UNITED STATES PATENT AND TRADEMARK OFFICE

APPLICATION NO.	FILING DATE	FIRST NAMED INVENTOR	ATTORNEY DOCKET NO.	CONFIRMATION NO.
10/564,226	05/31/2006	Franz Thoemmes	10191/4495	7534
26646 7590 05/19/2008 KENYON & KENYON LLP ONE BROADWAY NEW YORK, NY 10004				
EXAMINER BOECKMANN, JASON J				
ART UNIT		PAPER NUMBER		
3752				
MAIL DATE		DELIVERY MODE		
05/19/2008		PAPER

Office Action Summary

DETAILED ACTION

Examines Marked up Figure 9

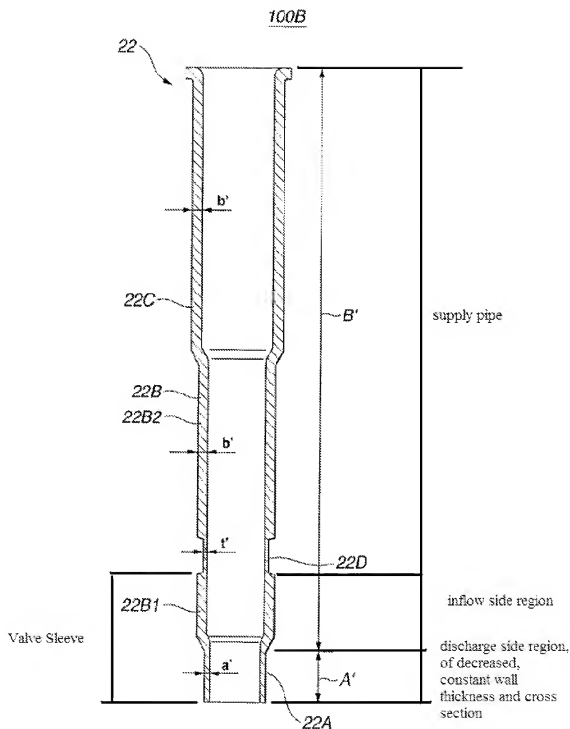
Kobayashi et al. shows a fuel injector (1) comprising; a valve needle (7a) an armature (7c) forming an axially movable valve port together with the valve needle, a restoring spring (9) acting upon the armature, a magnetic coil (11) cooperating with the armature, a valve-seat body (5b), a valve closure member (7b) which forms a sealing seat with the valve seat body and; a valve sleeve (22B1, 22A) surrounding the armature and the valve needle, a wall thickness of the valve sleeve varying across its axial

direction (fig 9), wherein the wall thickness of the valve sleeve decreases in a discharge direction of a fuel (figure 9), wherein a radial cross section of the valve sleeve decreases between an inflow-side region and a discharge-side region on a color (figure 9), wherein the radial cross section and the wall thickness of the inflow-side region are constant from the collar to an inflow-side end of the valve sleeve (figure 9); wherein the decreased radial cross section and decreased wall thickness of the discharge-side region are constant from the collar to a discharge-side end of the valve sleeve (see examiners marked up figure of figure 9), and wherein the inflow side region of the valve sleeve is formed in one piece with a supply pipe (see examiners marked up figure 9).

Regarding the applicant's remarks towards the rejection of claim 8, it is noted that the location of the “inflow-side of the valve sleeve,” is not specifically claimed, the examiner is considering the inflow-side end of the valve sleeve to be everything below the indent 22D to the lower collar shown in the marked up figure 9 shown above. Therefore, the valve sleeve has a constant wall thickness and cross-sectional area from the collar to the discharge-side end of the valve sleeve, and the collar to the inflow-side end of the valve sleeve.
